4. SO₂ BART EVALUATION

Entergy Services, Inc. on behalf of Entergy Louisiana, Inc. (Entergy) has reviewed the above-referenced documents provided by U.S. EPA Region 6 (EPA) and provides the following comments to assist the Louisiana Department of Environmental Quality (LDEQ) in finalizing its regional haze state implementation plan (SIP). In general, EPA's March 10th critiques are not novel and have been addressed in previous reports and correspondence between Entergy, EPA, and LDEQ, most recently in the response to comments letter provided by Entergy on January 20, 2017, and the Comprehensive Air Quality Model with Extensions (CAMx) Modeling Report submitted on October 14, 2016 (2016 CAMx Modeling Report).

Response of: Entergy Texas, Inc.
to the Fourth Set of Data Requests
of Requesting Party: Sierra Club

Figure 1. Deciview-Extinction Curve – Generic Comparison of Clean and Dirty Background Calculations

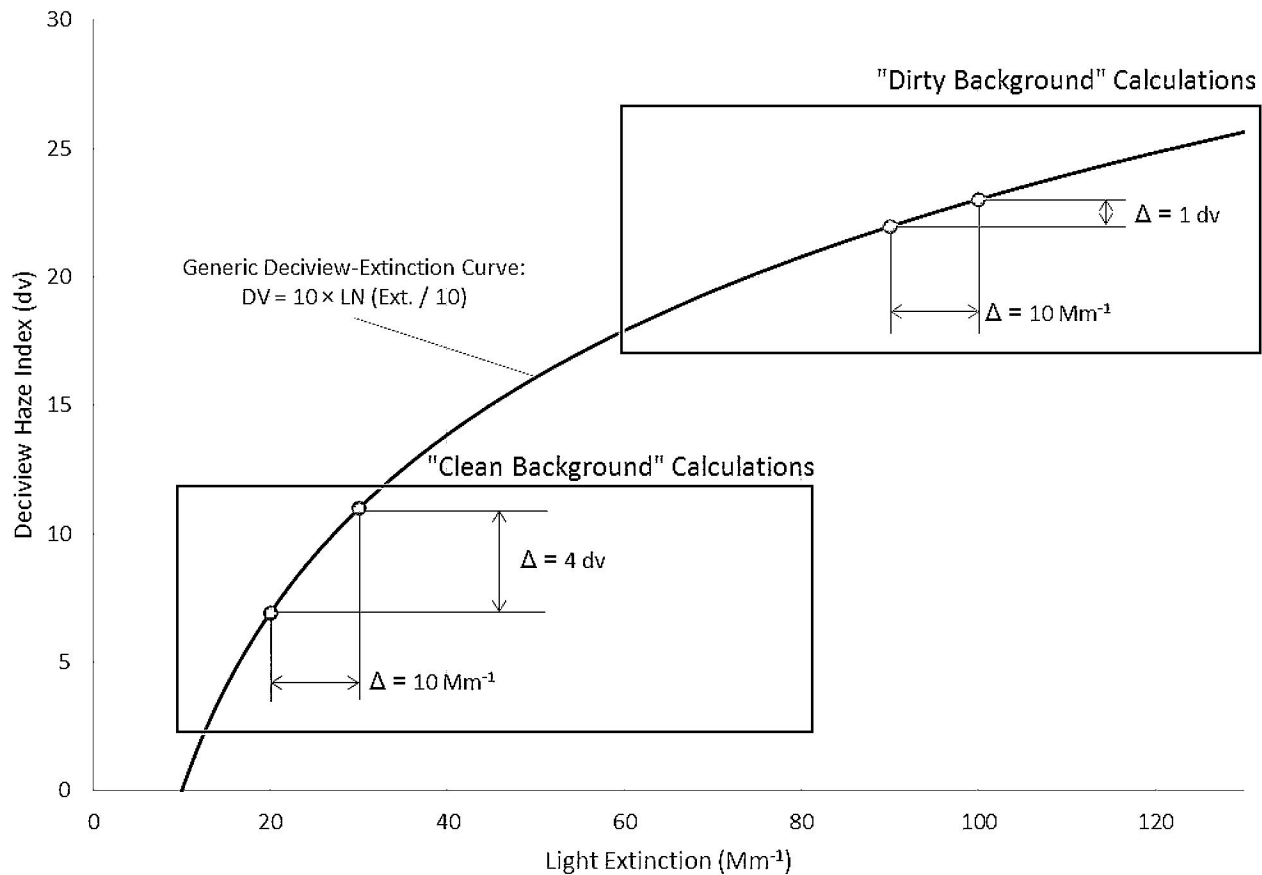
Depending on the background condition at which potential control technology visibility improvements are evaluated (i.e., where on the deciview visibility curve the benefits are applied), the logarithmic nature of the deciview metric can result in widely varying deciview improvements for identical extinction changes. For example, hypothetically, a clean background approach might translate a 10 Mm^{-1} change in light extinction into a 4 dv improvement, while the same 10 Mm^{-1} change might equate to only 1 dv relative to dirty background conditions. Figure 1 below illustrates this general example of logarithmic variation.

Figure 2. Observed (IMPROVE) Percent of Total Extinction by Species for 20% Worst Days at Breton Wilderness Area

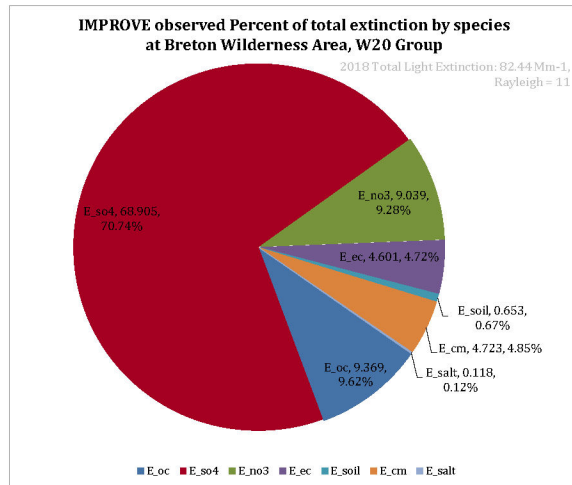
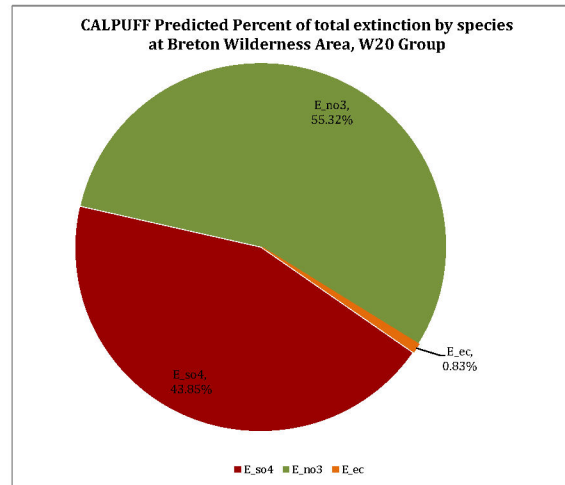
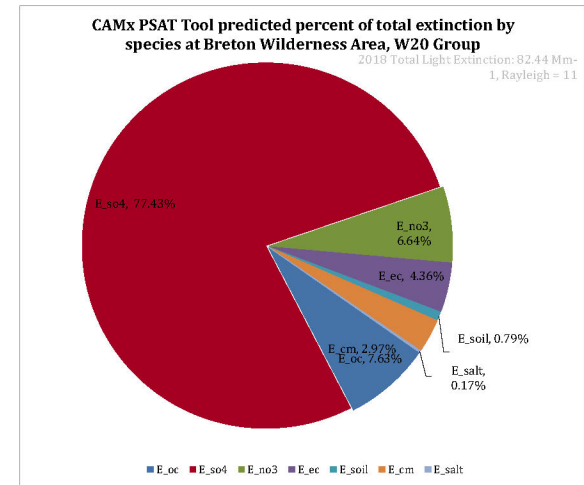
The CAMx modeling system is capable of incorporating the influence and contribution of all emissions inventory sources (including both biogenic and anthropogenic sources) into its visibility projections (giving one of several reasons for its better predictive value over CALPUFF). This allows CAMx to estimate the visibility baseline impacts and control technology benefits based on the dirty background methodology, resulting in more realistic visibility predictions relative to the actual visibility conditions during a given time period. Therefore, the baseline visibility
